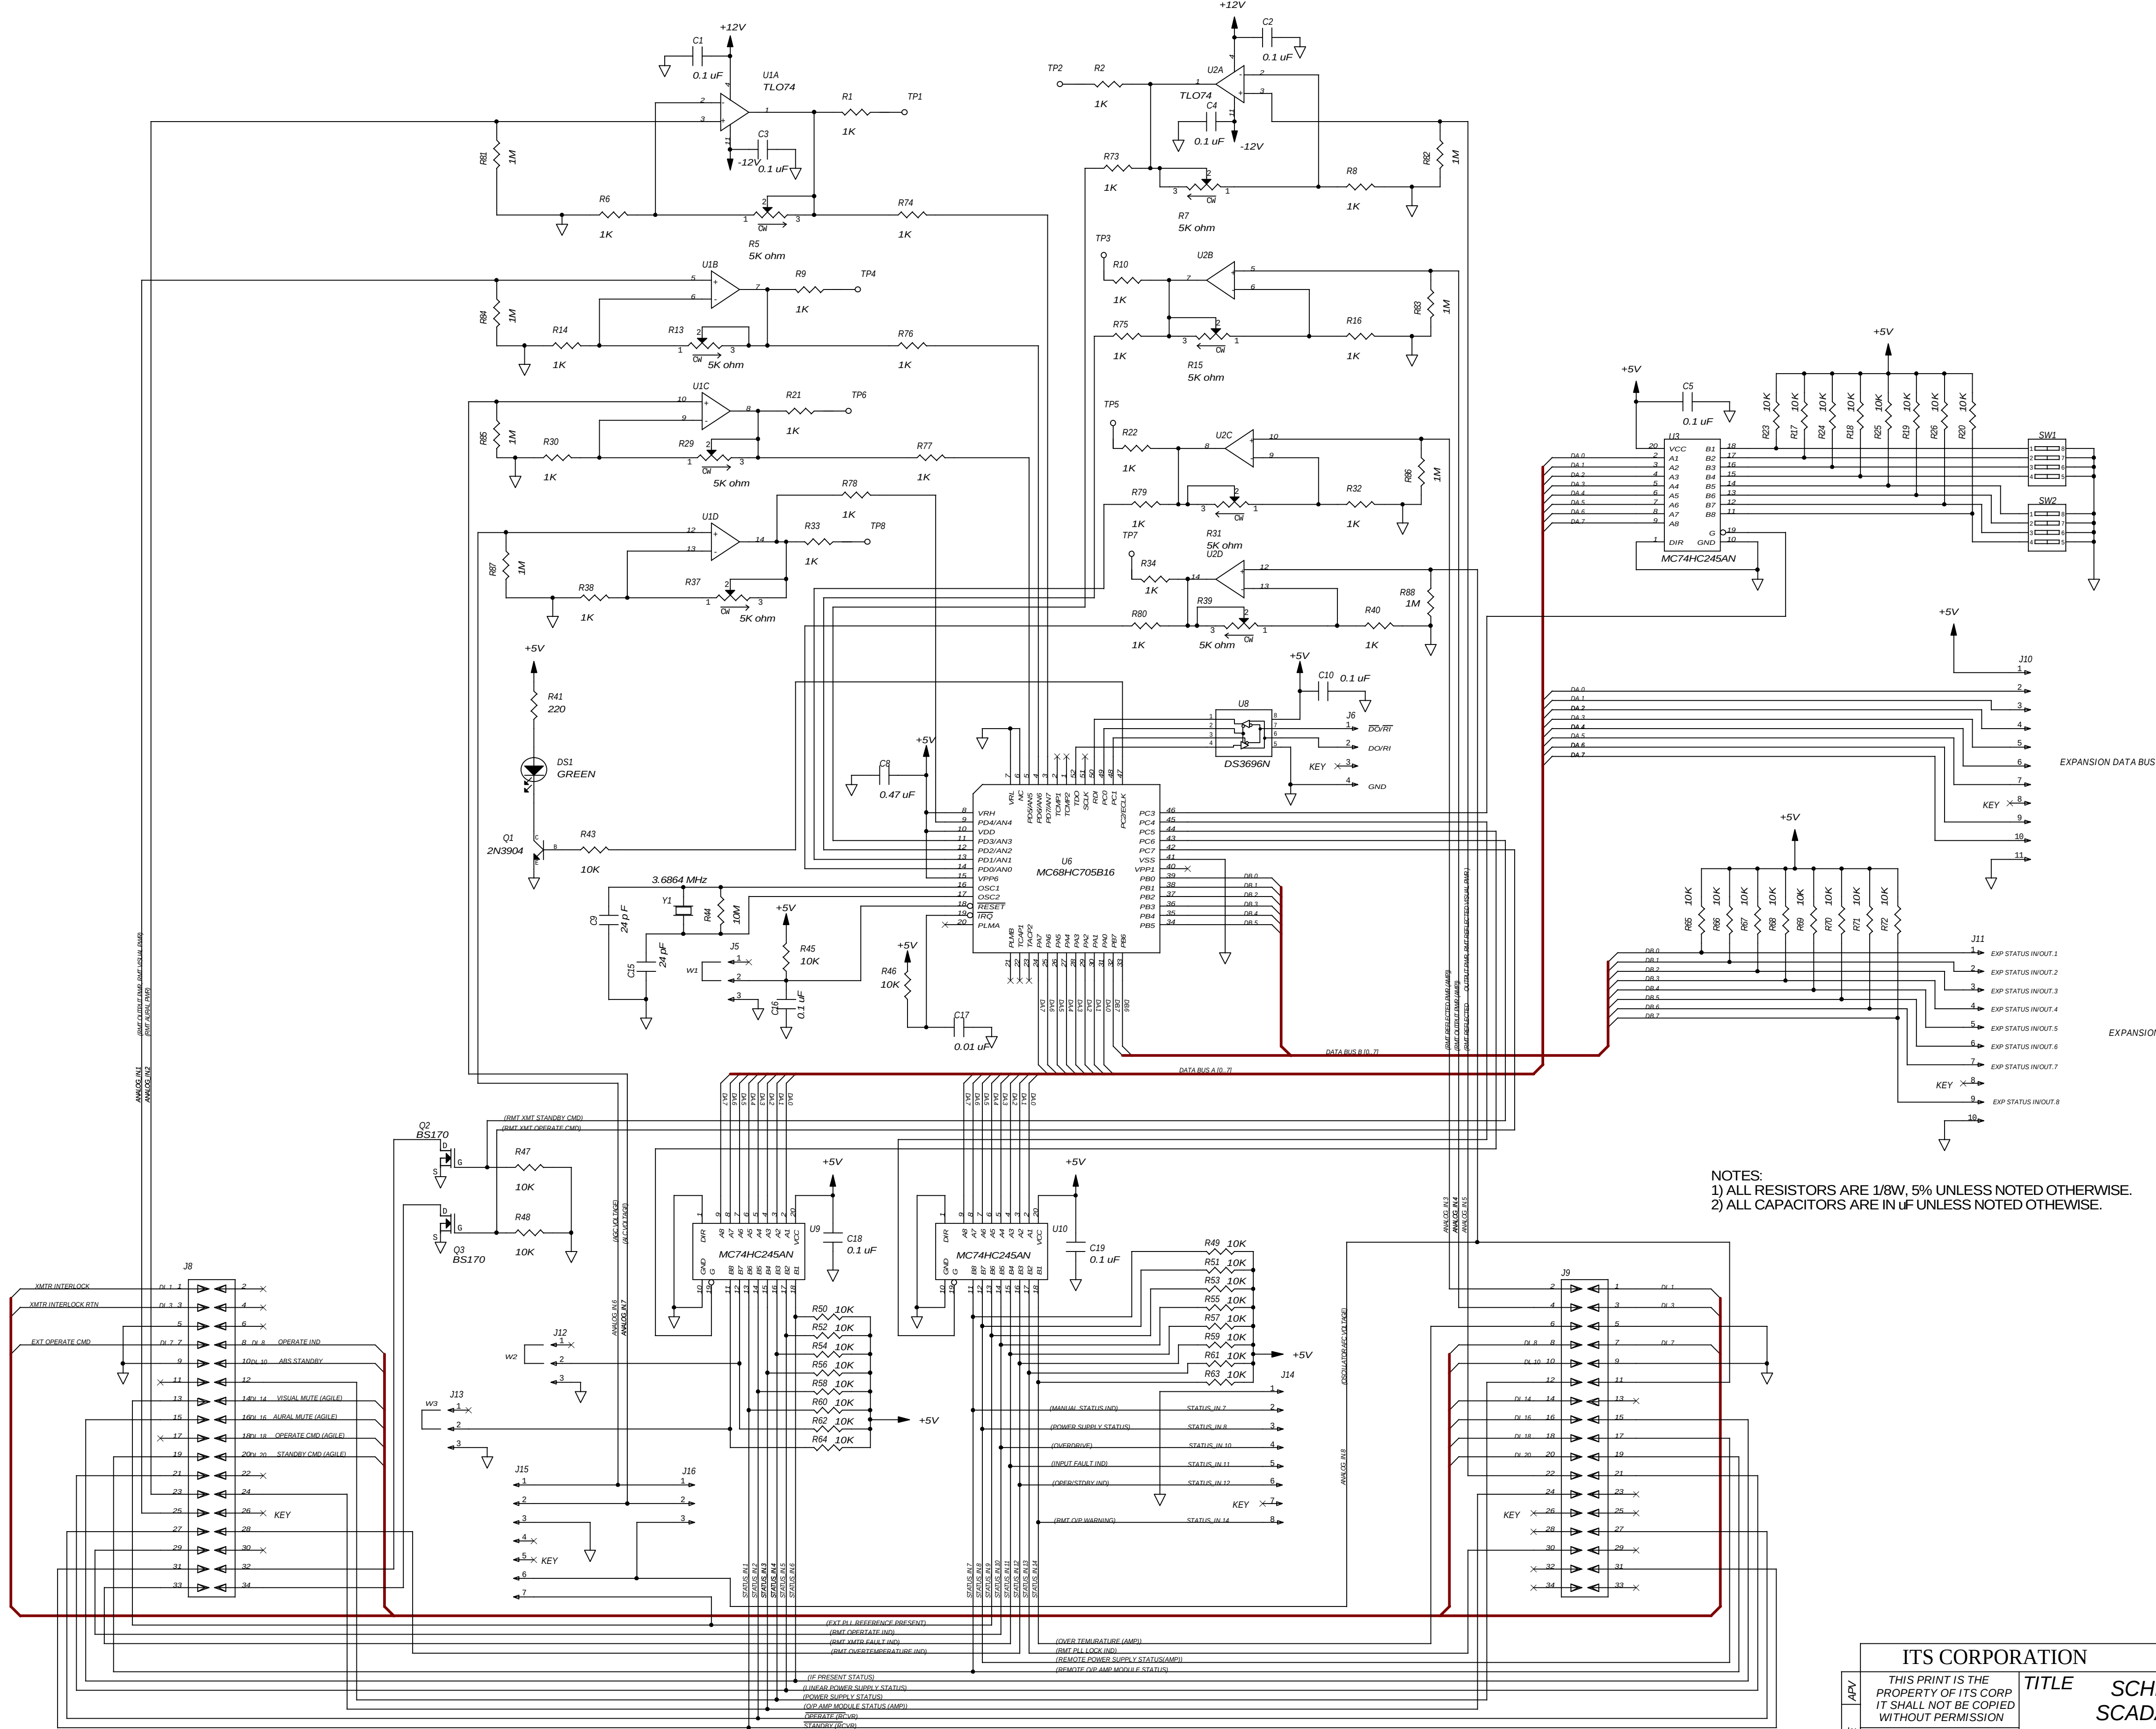
DELETED CONNECTION
BETWEEN R46 AND J8-10.
DELETED R3, R4, R11
R12, R27, R28, R35, R36.
CONNECTED U6-6 TO
GND. ADDED NOTES 1
AND 2. (PJK)

Y1 WAS 4.0 MHz DLM

DELETED "(AMP)" FROM U10-11.
ADDED "(AMP)" TO U9-15. ADDED
CONNECTION- J8-19 TO U10-11. A
NEW NETLIST WAS NOT CREATED.
BOARD HAS REWORK ON IT. RT.

R3,4,11,12,27,28,35,36 WAS 470 OHMS.
ADDED (8) 1 MEG RESISTORS TO U1 &
U2 INPUTS. MADE U6 PIN 40 A
NO-CONNECT. J10 WAS 10 PIN. DLM
